A d d e n d u m

Iowa Department of Transportation
Office of Contracts

B.O.	Proposal ID	Proposal Work Type	County	Project Number	Addendum
005	42-C042-077-A	BRIDGE AND APPROACHES - CCS	HARDIN	BRS-C042(77)--60-42	20OCT005.A01

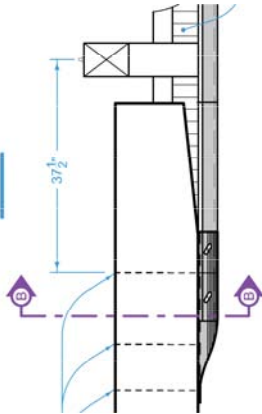
Replace plan sheet 13 with the attached.

Note revised "STEEL BEAM GUARDRAIL AT CONCRETE BARRIER OR BRIDGE RAIL END SECTION" tabulation 108-8A.

SA-202

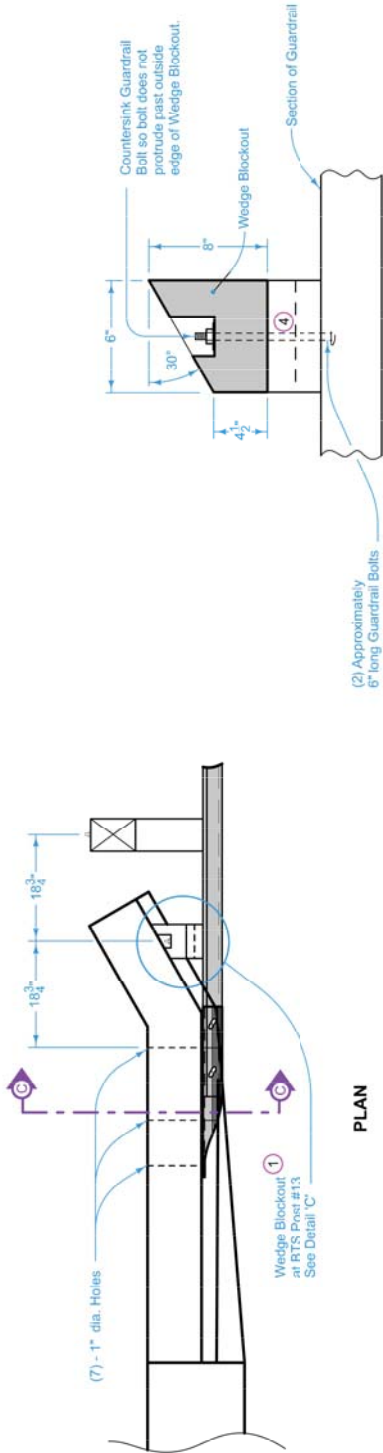
VISIONS - Changed label from Bridge End Post to Bridge
